ACTION MEMORANDUM

ANACONDA CO. SMELTER NPL SITE
ARBITER AND BERYLLIUM OPERABLE UNITS
ANACONDA, DEERLODGE COUNTY, MONTANA

SUBJECT: Request for scope change to Removal Action at Anaconda Smelter Superfund Site, Arbiter and Beryllium Operable Units, Deer Lodge County, Montana

PROFILE
RCRA DISPOSAL CELL, N/S & E/W
SCALE: 1" = 40' H
1" = 12' V

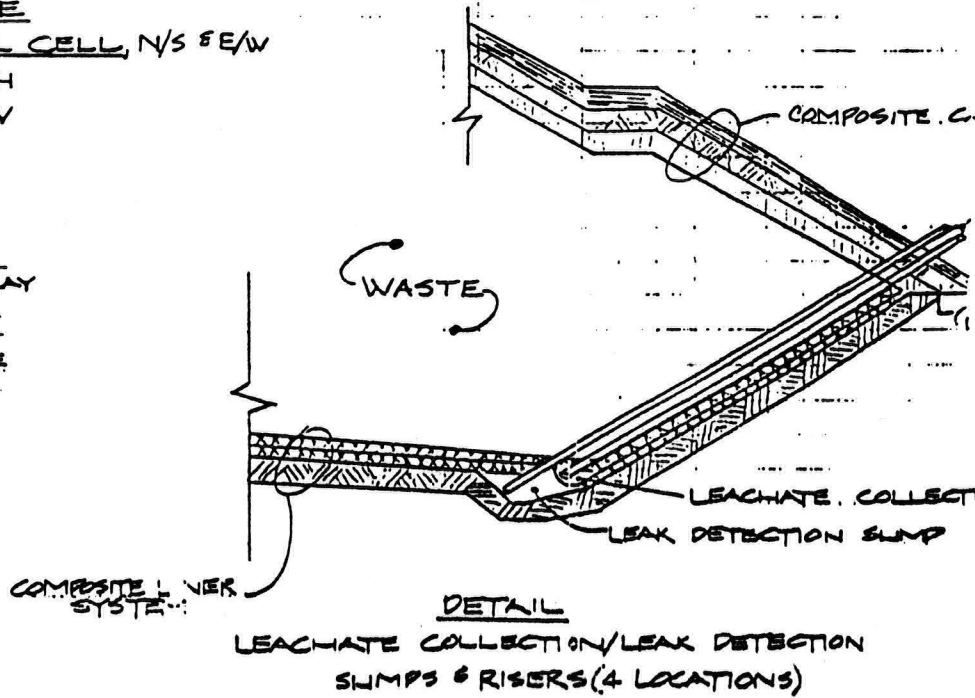
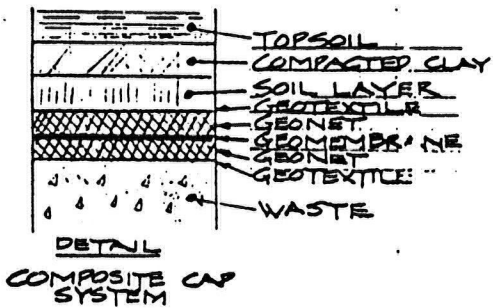
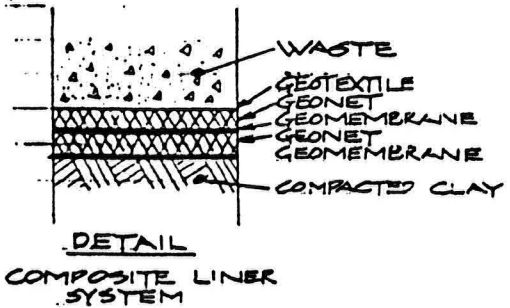
The proposed change will result in a disposal cell lined with a double geomembrane liner system overlaying a synthetic liner of very low permeability. The landfill cover will consist of a composite cap of topsoil, synthetic liner and a single geomembrane. The repository will meet all applicable or relevant and appropriate RCRA Subtitle C and Montana Hazardous Waste Act design requirements.

- o A conceptual drawing of the disposal cell is shown in Figure 4. The preliminary design shows the landfill as a 440-foot square facility covering approximately 4.5 acres. The containment cell will be lined by a double geomembrane liner system overlying three feet of low-permeability compacted clay. The landfill cover will consist of a composite cap of topsoil, clay, and a single geomembrane. Maximum waste deposit depth will be about 30 feet. The repository will meet all applicable or relevant and appropriate RCRA Subtitle C and Montana Hazardous Waste Act design requirements. A detailed investigation will be performed to adequately describe the site conditions such as topography, foundation properties and availability of construction materials. Attached is a Statement of Work for implementing the removal action.
